Permit Application Review Report
Date: 6/3/2026

Project Name: Jim Peterson Park Improvements

Project PAN: P-26-024

Project Purpose: Parking lot expansion, ice rink construction and associated utility and stormwater management

Figure 2: Site Plan

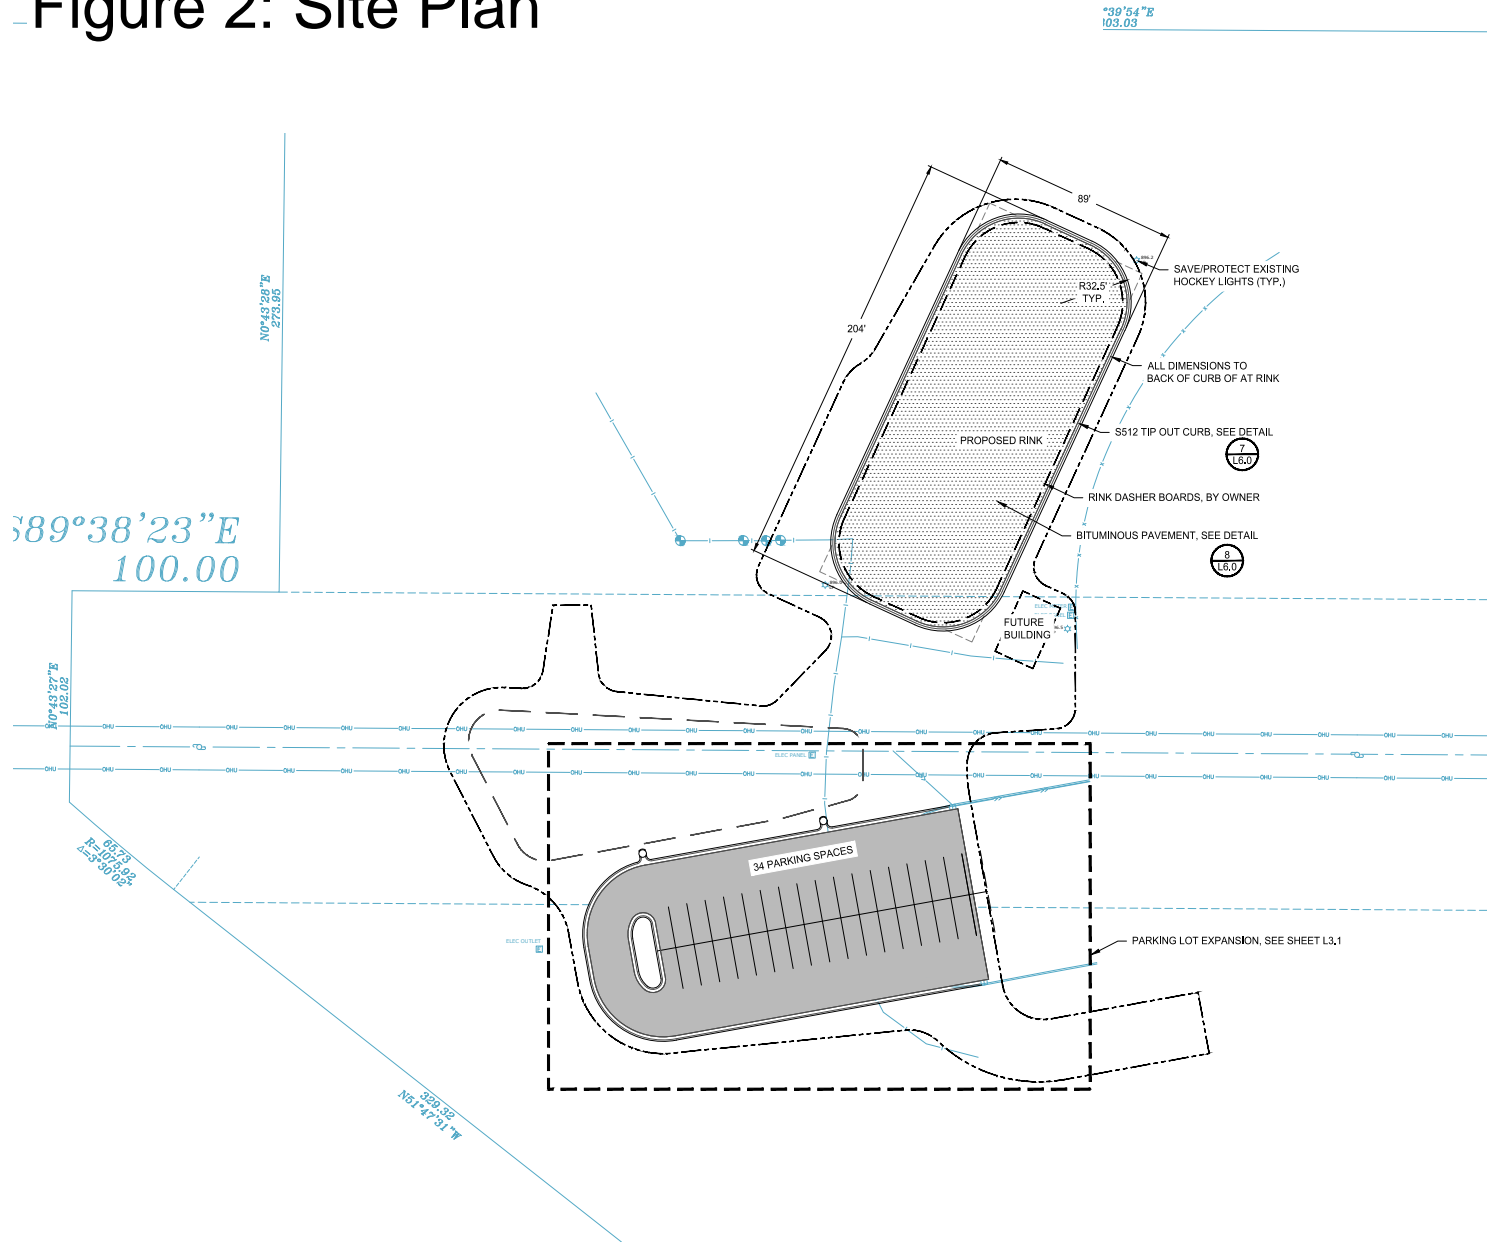
Description: The City of Blaine is proposing improvements to Jim Peterson Park, which include an ice rink, new parking area, and associated stormwater treatment features. The project will disturb 1.4 acres and create 0.76 acres of regulated impervious surface. The site drains to County Ditch 41. The relevant water resource concerns are stormwater management, soils and erosion control and floodplain impact, which are District Rules 3, 4 and 6. See attached Figure 1: Project Location and Figure 2: Site Plan.
